Errata

The 2nd Ed. of Old-Time Telephones is remarkably error free considering the huge amount of technical information, including entries in 27 tables and more than 120 original diagrams. Corrections were made for the second printing of the 1st Ed. and again for the 2nd Ed. Subsequently, Old-Time Telephones was used as the text for an on-line course called Telephony 101, and this thorough re-examination has flushed out a few more minor errors, which are identified below.

Fig. 17-14 Corrected

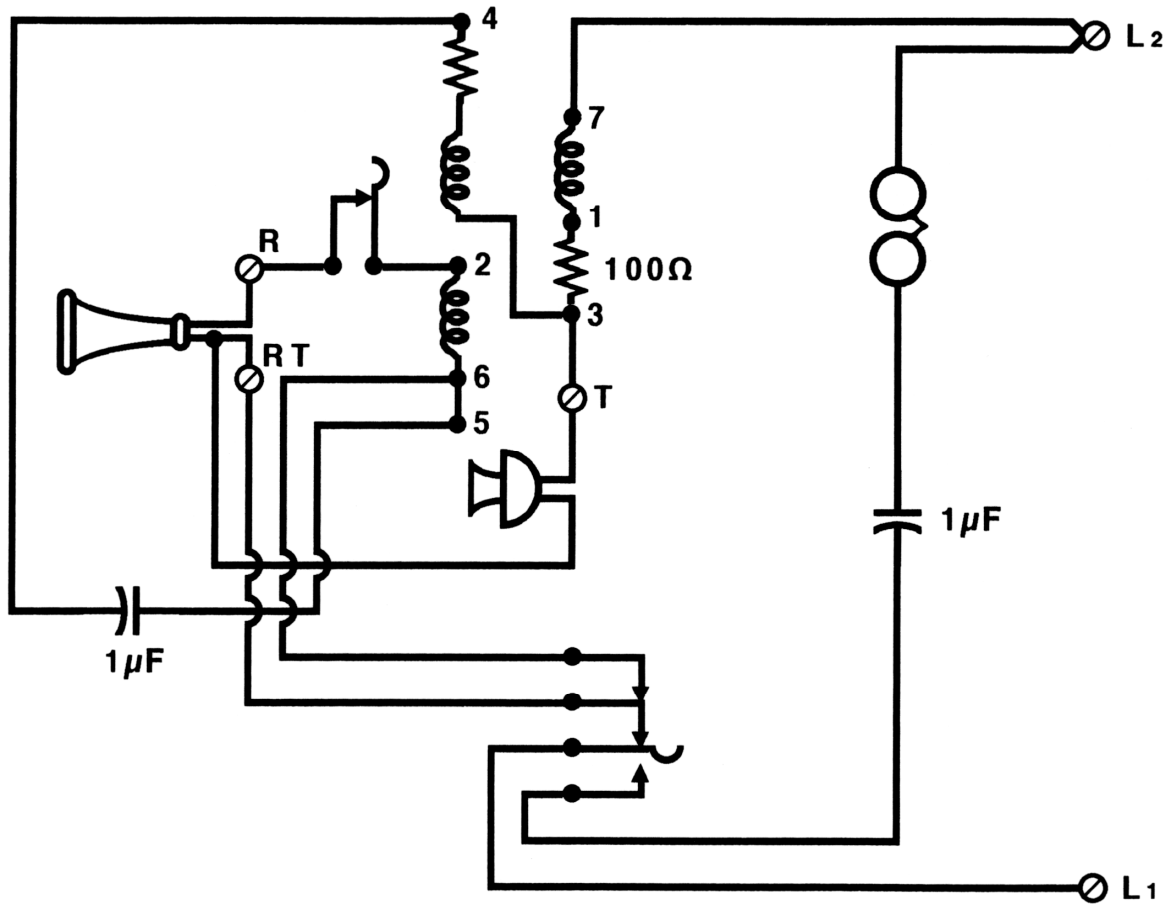
- Page 121. In the section heading, replace the last word “Dial” with “Dials.”
- Page 137. In Fig. 17-14, interchange the labels L1 and L2 (modified figure provided below).

Fig. 17-18 Corrected

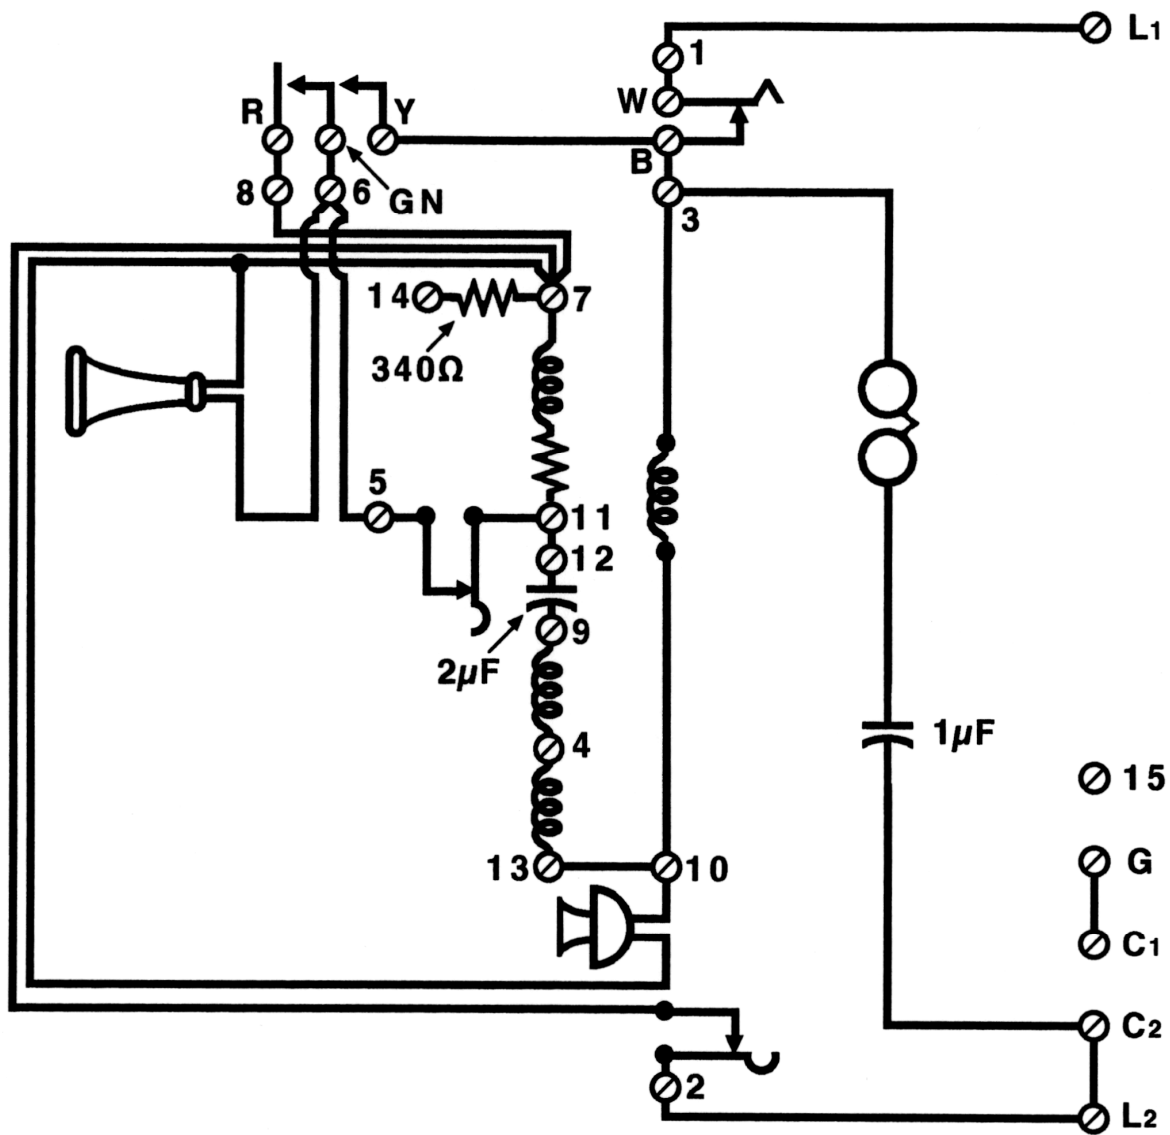
- Page 140. In Fig. 17-18, interchange the labels 8 and 6 (modified figure provided below).
- Page 151. In Fig. 18-7, add two terminal labels, L1 and GND (modified figure provided below).

Fig. 18-9 Corrected

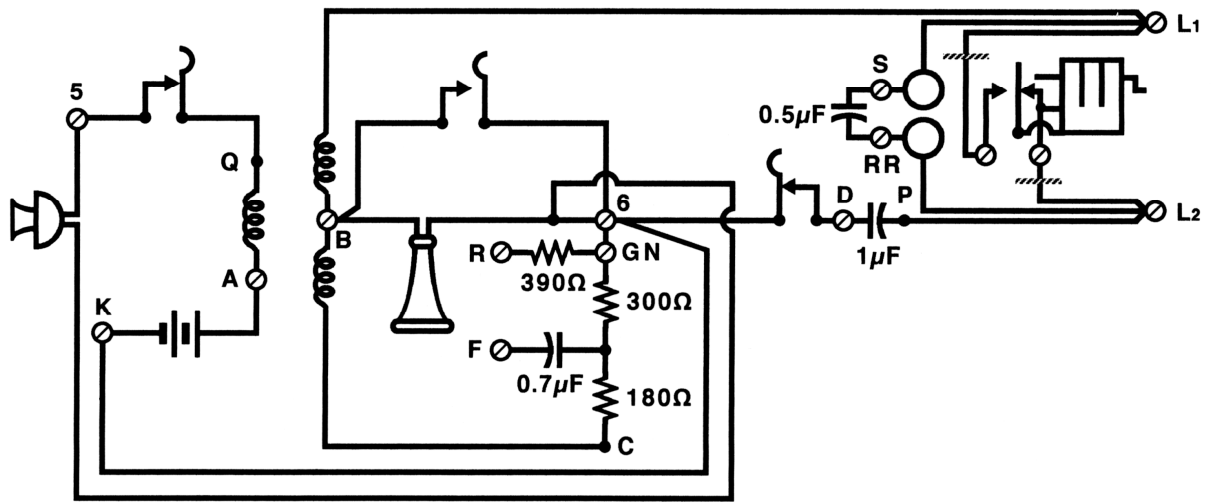
- Page 154. In Fig. 18-9 at terminal Q, replace the symbol for a screw terminal with the symbol for a solder terminal (modified figure provided below).
